October 2020 BAR Action

Certificate of Appropriateness Application

BAR 20-09-05

Bank of America exterior lighting

1 PHOTOMETRIC PLAN
E04.01 1" = 10'-0"

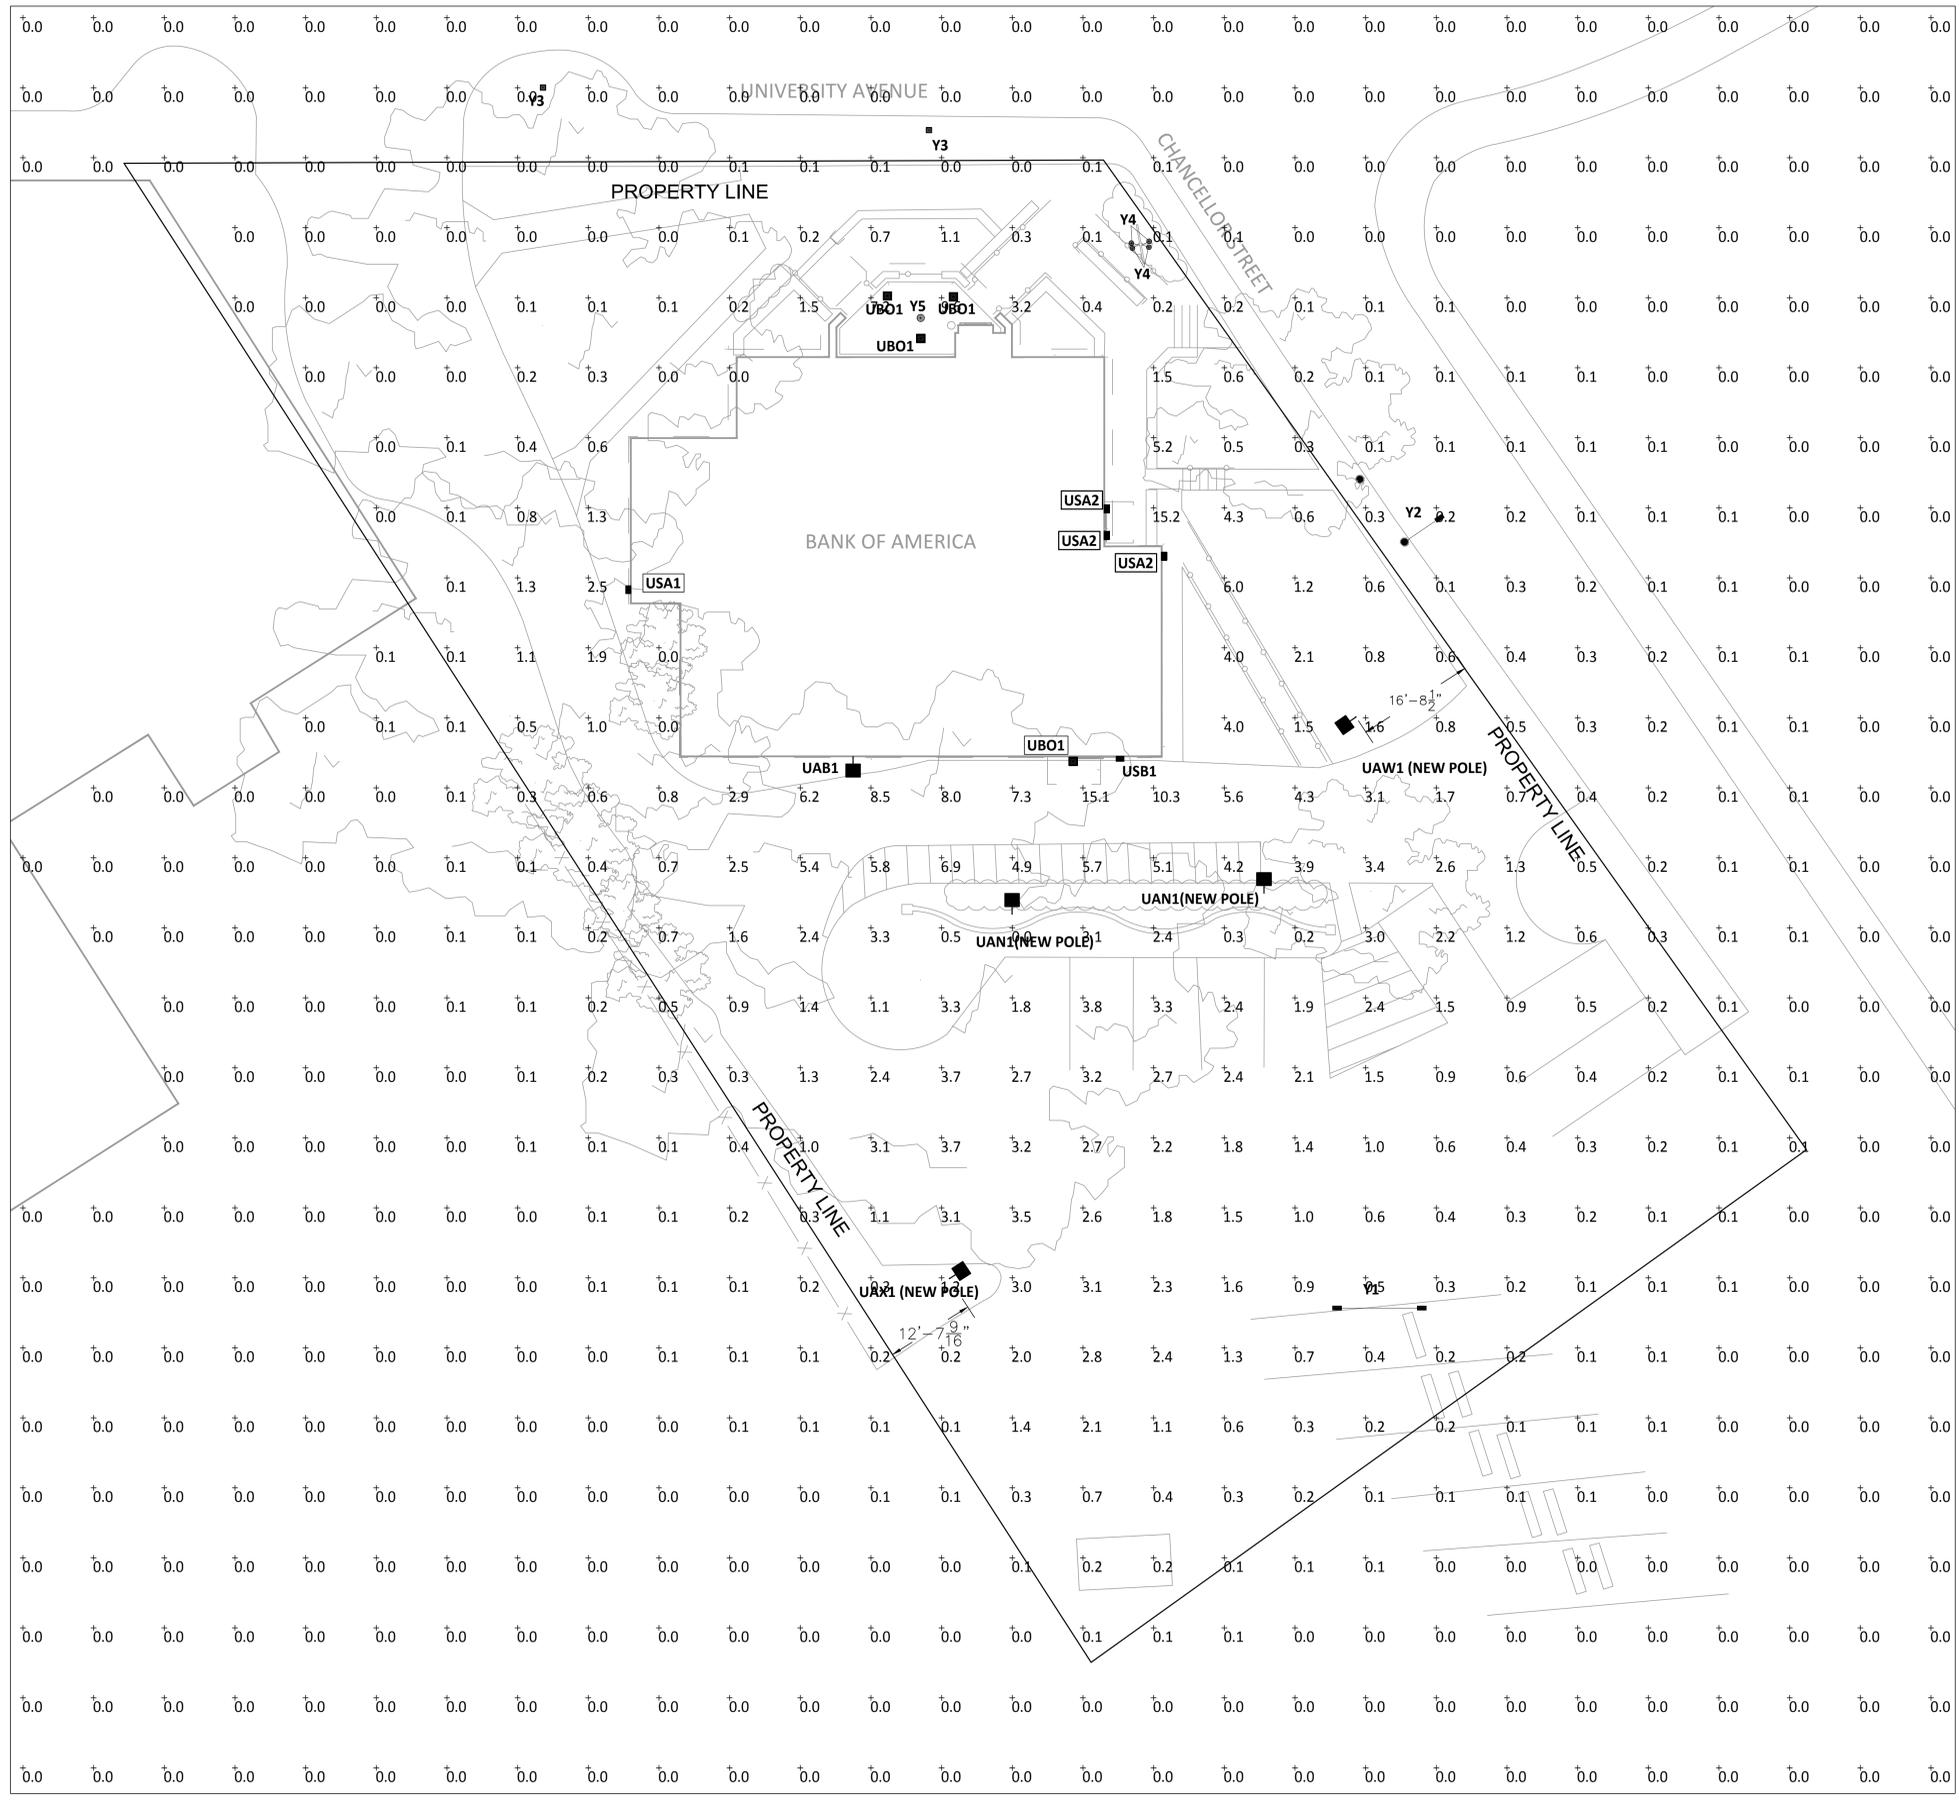
Comment 1. As per City Code Sec. 34-1003(d), the spillover light from luminaires onto public roads and onto property within any low-density residential district shall not exceed one-half (½) foot candle. There is too much spillover in areas along the northern and eastern borders of the property

Response: Lighting plan has been updated along the northern and eastern borders of the property to prevent a spillover greater than one-half foot-candle.

- Updated to lower number of fixtures on and around building.
- Updated fixture strengths to lower lighting around building.
- E01.01 updated per new lighting fixture schedule on E03.01.
- E02.01 updated per new lighting fixture schedule on E03.01.
- E03.01 updated lighting fixtures.
 - All fixture color has been updated to 30k.
 - AG1 updated to UAW1 (Double to single fixture arrangement, lower wattage).
 - AG2 updated to UAB1 (lower wattage).
 - AJ1 updated to UAX1 (Triple to single fixture arrangement, lower wattage).
 - AR1 updated to UAN1 (Double to single fixture arrangement, lower wattage).
 - AR2 Removed from plan (Pole fixture by main road).
- E04.01 Photometric plan has been updated per new fixtures.
